ADDENDUM NUMBER ONE (1)

Issuance Date: October 16, 2025

Issued by: Ashe Broussard Weinzettle Architects LLP

Project Name: Workforce Capacity and Medical Access Project
LaSalle General Hospital
Jena, Louisiana
EDA Number 08-79-05595
Architect Project Number 2024.01

project no.
2024.01
drawn
MAN
checked
DBS
project date
JAN 2025
drawing no.
E1.1R1

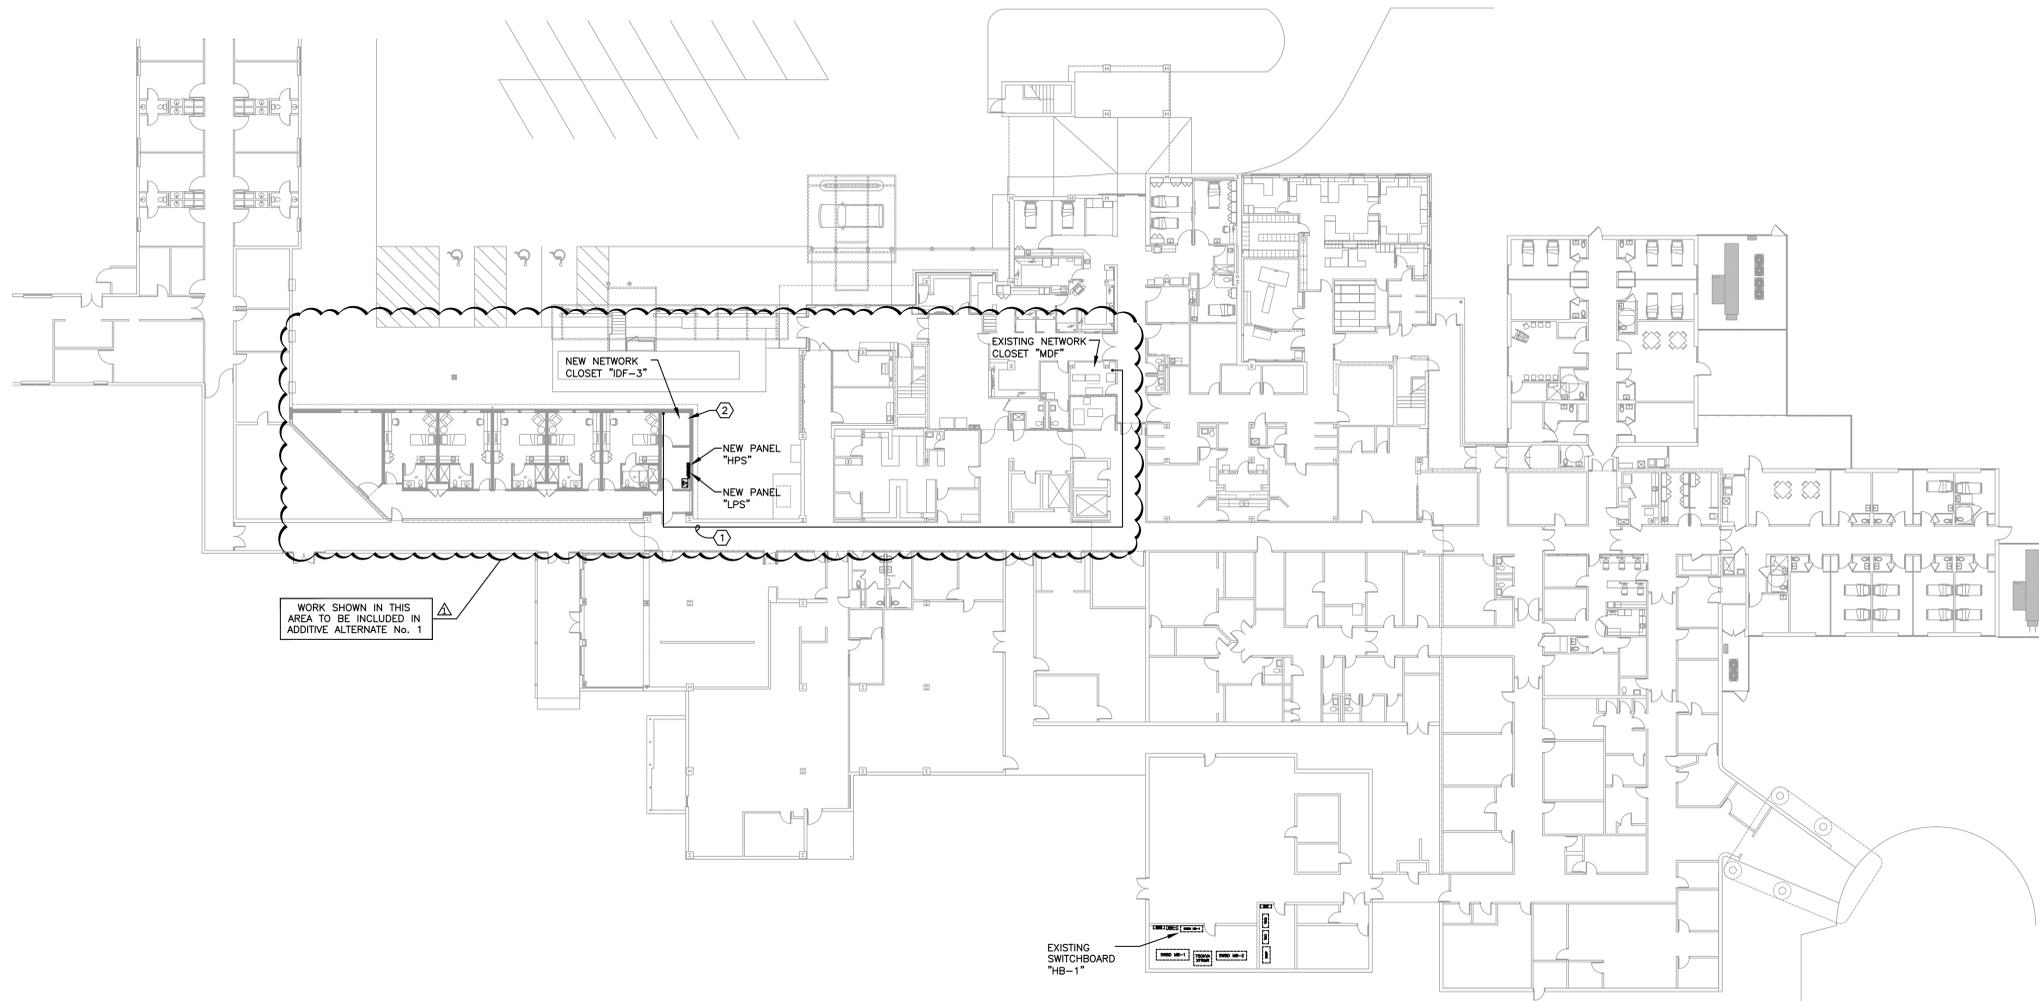
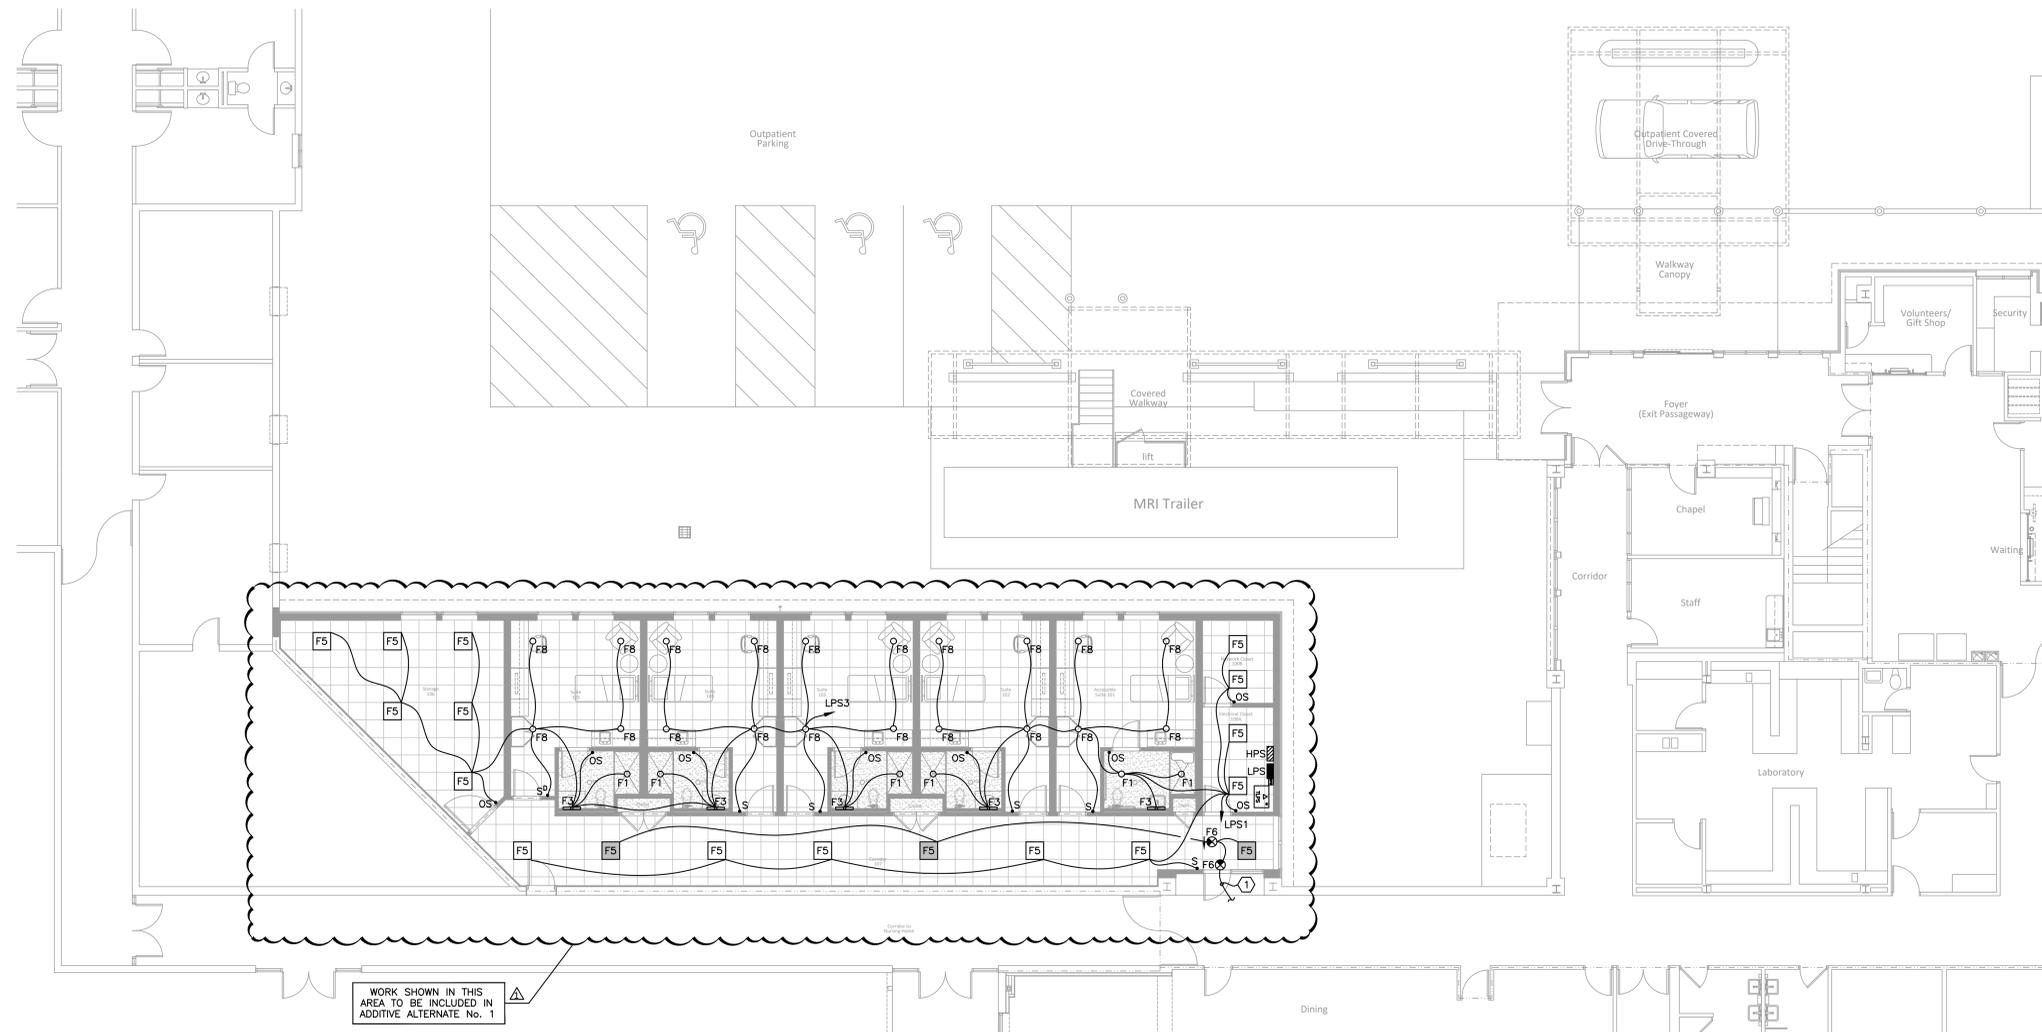
1. Drawing E1.1R1
 - a. Replace E1.1 in its entirety with the attached E1.1R1. Changes to plan are clouded for reference.
2. Drawing E2.1R1
 - a. Replace E2.1 in its entirety with the attached E2.1R1. Changes to plan are clouded for reference.
3. Drawing E3.1R1
 - a. Replace E3.1 in its entirety with the attached E3.1R1. Changes to plan are clouded for reference.
